Instrument Engineering Change Notice

NO. Glas g2-2201

Title: Release of Service Manual with new document code and Amendment of Service Manual

AMENDMENT

6-5-19-3. Replacement of Gas Damper

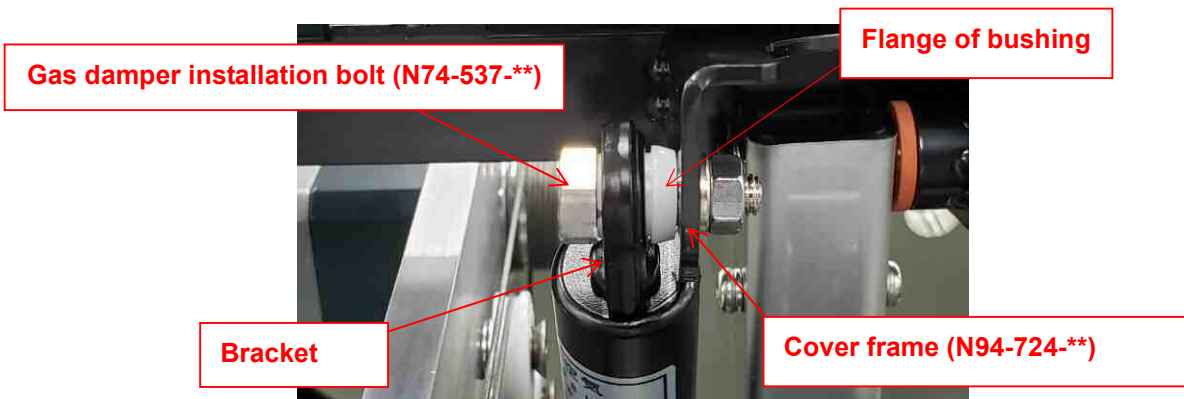
1. Install the parts by following the disassembly procedure in reverse.
 - Be sure to assemble the gas damper with the tube side facing up.
 - When operating the gas damper, be sure to erect the damper with the tube side facing up.
 - The gas damper should display resistance when extending as well as contracting.
- Observe precaution described on the next page when replacing the gas damper with the new part, Gas Spring TG221-70-300 (380)-TK (18-8) (part code 00001-2814).

Precaution for Installation of Gas Spring TG221-70-300 (380)-TK (18-8) (Part code 00001-2814)

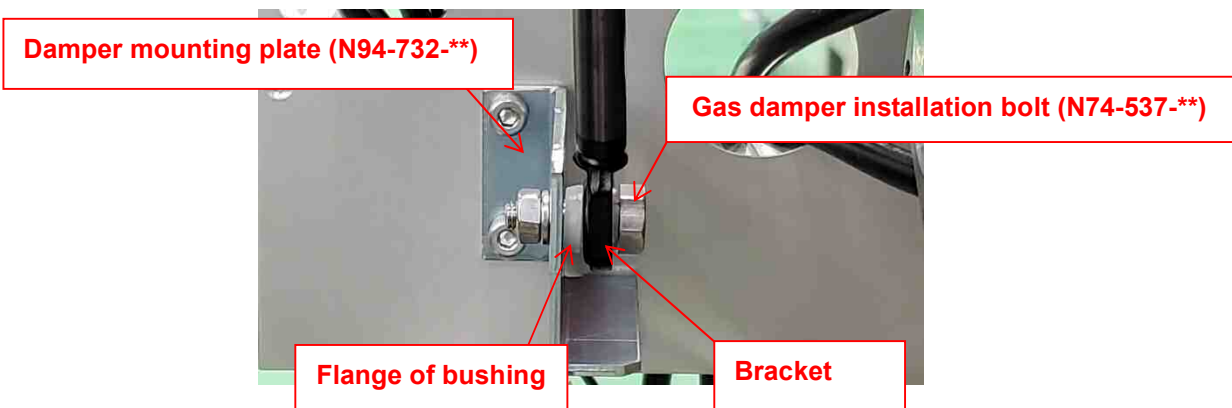
Due to production discontinuation, the gas damper Y1035 (D9280088) was changed to the gas spring TGS221-70-300(380)-TK (18-8) (00001-2814). (IECN #Glas g2-2102 Part number change).

However, the gas damper and gas spring have differently-shaped mounting brackets. If the gas spring is installed in a wrong direction at replacement, a rod of the gas spring gets contact with the damper mounting plate (N94-732-**) during the opening/closing of the cover. This is just a minor contact problem and does not affect opening/closing the cover, yet it may cause the surface to be scratched or paint powders to be produced. To prevent such things, install the gas spring in a proper direction as shown below.

■ Cylinder Side

Secure the gas spring with the flange of the bushing faced toward the cover frame side.

■ Rod Side

Secure the gas spring with the flange of the bushing faced toward the damper mounting plate side.
